IREDELL COUNTY HEALTH DEPARTMENT

IMPROVEMENT PERMIT / AUTHORIZATION TO CONSTRUCT / OPERATION PERMIT / EXISTING SYSTEM

I've attached copies of the original permit and the new layout with the change in setbacks. Changing the setback to meet the relatively new requirement for foundation drains around crawl spaces still makes the system work, but the builders are pretty angry that they have to re-permit something they thought was a valid permit. The sun room has always been permitted as a sun room; my original email was based off a preliminary plan that we never submitted. The utility line only impacted a few feet in the rear right corner of the lot.

126 Keel Lane Fast Track Septic System Information

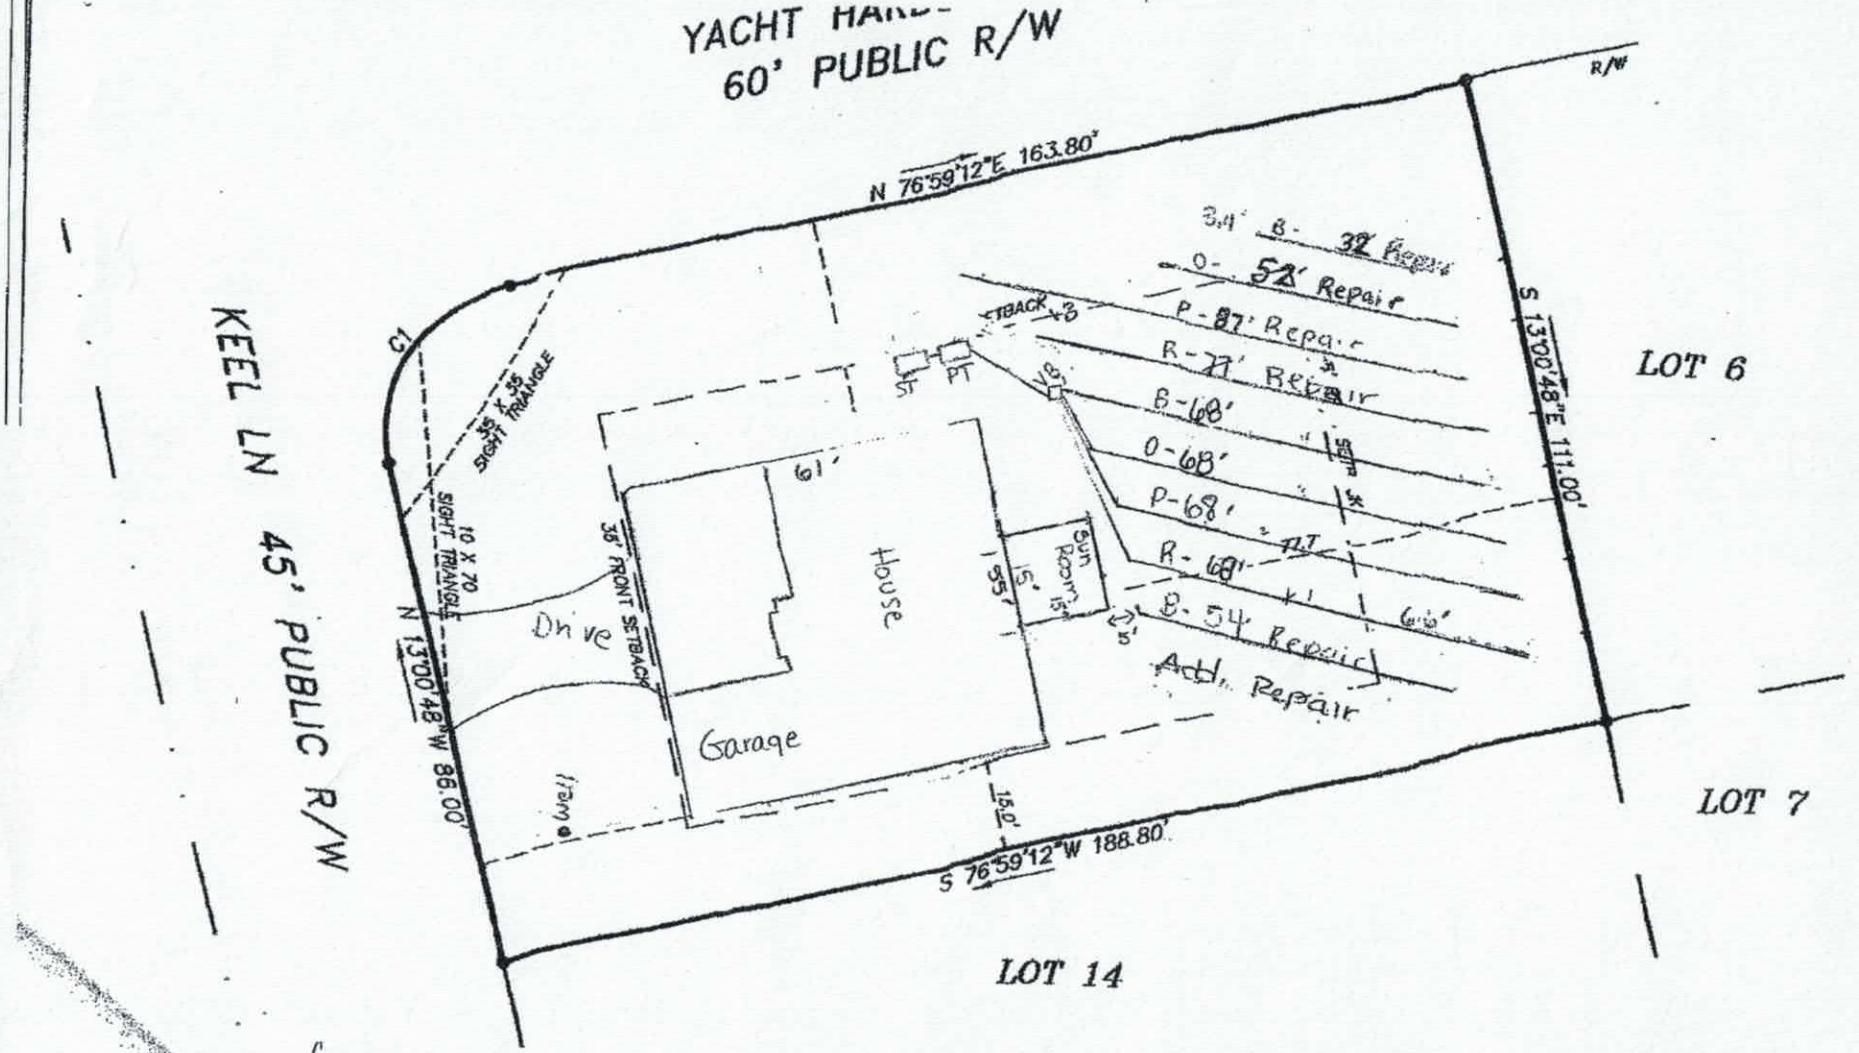
This is the lot on Keel and Yacht Harbor (126 Keel Ct) that we permitted last year. They added a foundation drain around the crawl space, made the deck a sun room, and then the utilities company slightly impacted the system area by roughing in the utilities outside of the 10 ft utility easement in some places (mainly in the back right corner of the lot).

The tanks are already installed and the installer is asking when they can finish the installation. This needs to be re-permitted first, right?

Yes, it needs a redraw.

Proposed Plan (Site Needs Slight Shaping)

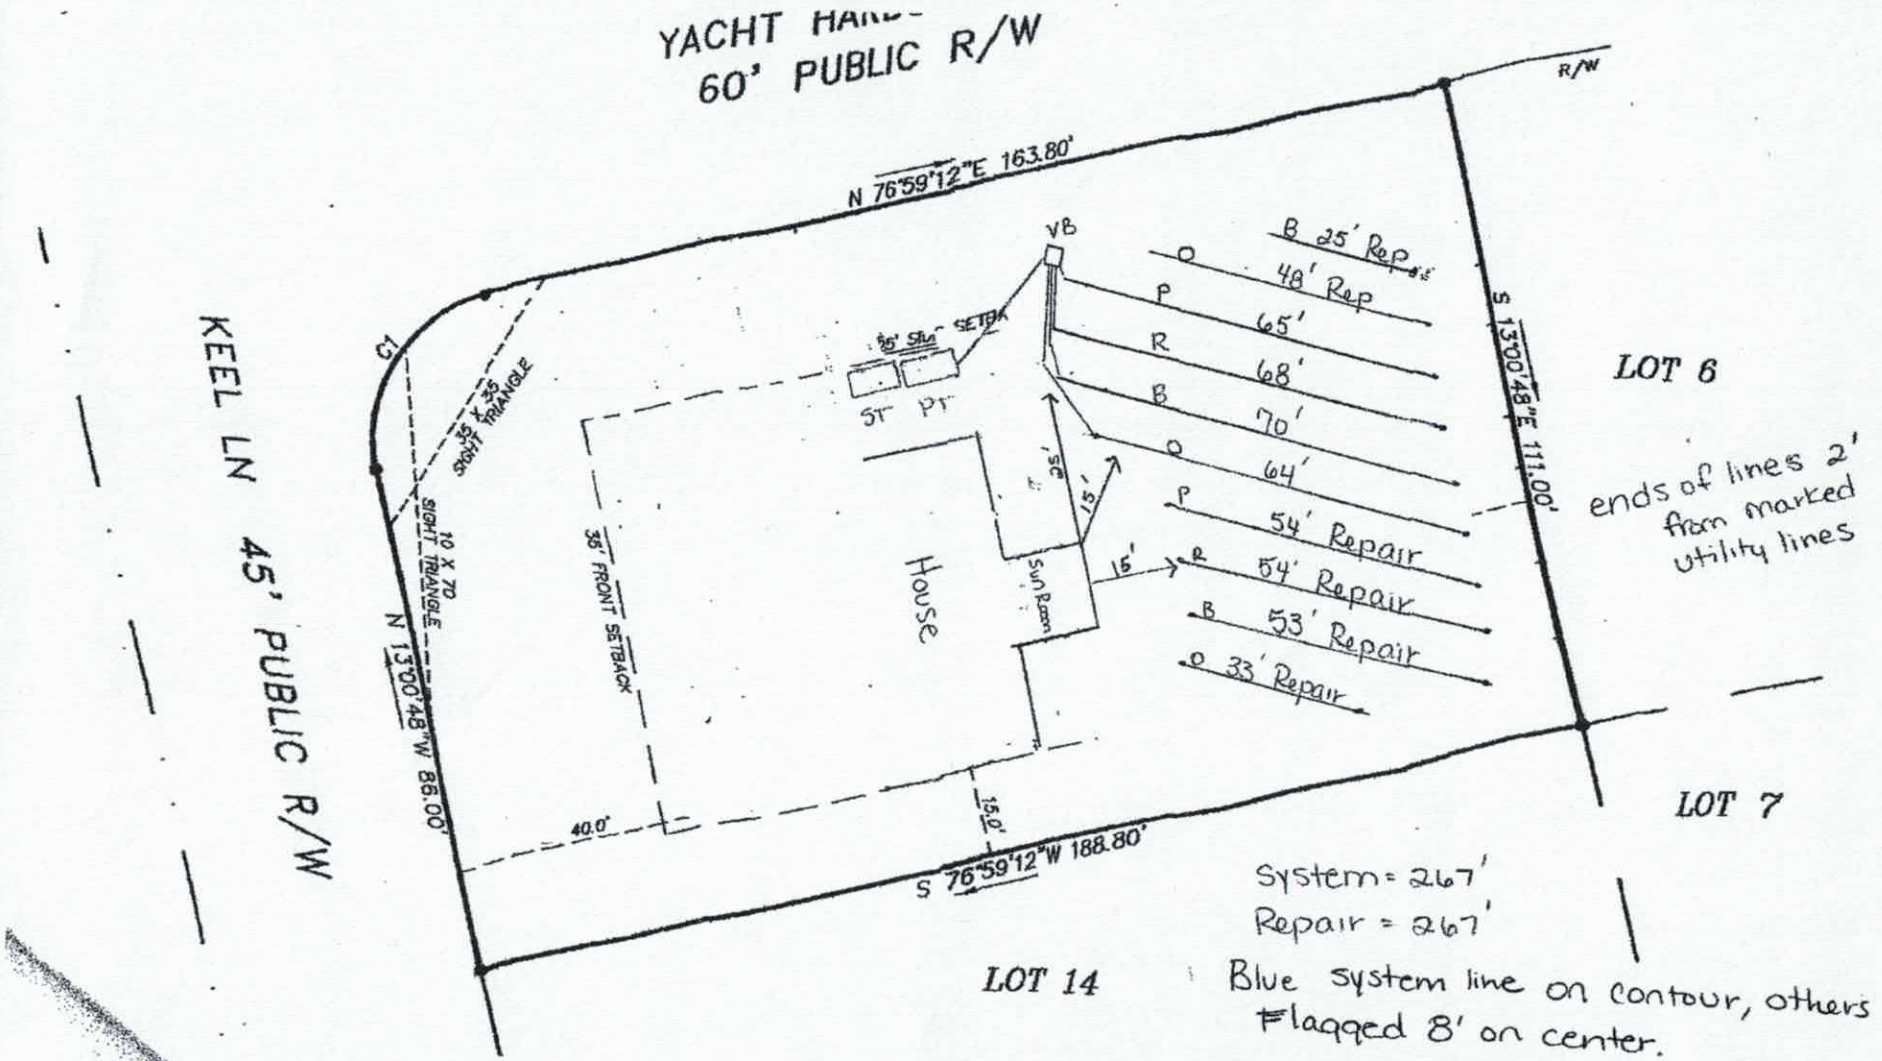
They would like to know if there's any sort of grandfathering for existing permits that use the old setbacks to crawl spaces?
